DOCKETED	
Docket Number:	22-SPPE-02
Project Title:	San Jose Data Center 04
TN #:	262637
Document Title:	Microsoft SJ04 Email Responses to Staff AQ related Questions
Description:	N/A
Filer:	Scott Galati
Organization:	DayZenLLC
Submitter Role:	Applicant Representative
Submission Date:	4/9/2025 2:32:40 PM
Docketed Date:	4/9/2025

Subject: New request for San Jose 04 data center

From: [Gregory Darvin](#)
To: [Ann Chu](#)
Subject: RE: Question regarding Overlap HRA of SIA
Date: Friday, April 4, 2025 4:54:37 PM
Attachments: [image001.png](#)
[See Table 4.3-28.docx](#)
[Screenshot.docx](#)

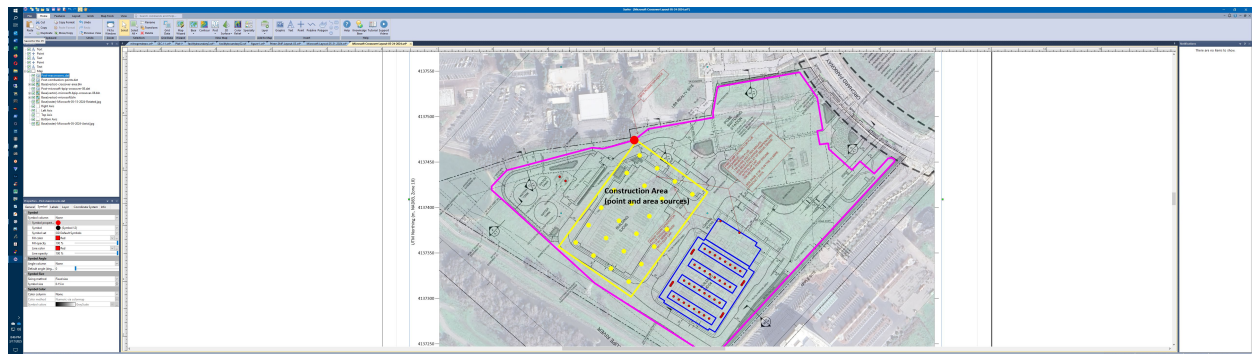
I noticed that there was a huge decrease in max concentrations from the first high receptor. Also noticed that the residential receptors did not seem to be impacted as much compared to the fence line receptors.

I plotted up the location of the max impact and noticed it was right next to the area source, which was the giveaway. There shouldn't be an area source for DPM. The only DPM is from the combustion construction equipment (yellow dots) and the red dots (diesel gen sets). As it turns out, it was the area source for PM10 fugitives which was included as a DPM emissions source when it summarized the results in the plot files. The red spot below is the max location receptor (229 in a million) and the yellow outline is the area source of fugitive dust.

I am wondering if you know why the cancer risk of PM10 during overlap is so high (229). I checked the AQ part and the levels look ok. Thanks.

I removed the fugitive dust source and reran the HRA (yellow and red dots) and the results went way down (I have attached the zip file with the crossover HRA files and AERMOD files). Max PM10 is now 9.06 in a million. I have also revised Table 4.3-28 for the worker, residential and school locations. The chronic values were also updated.
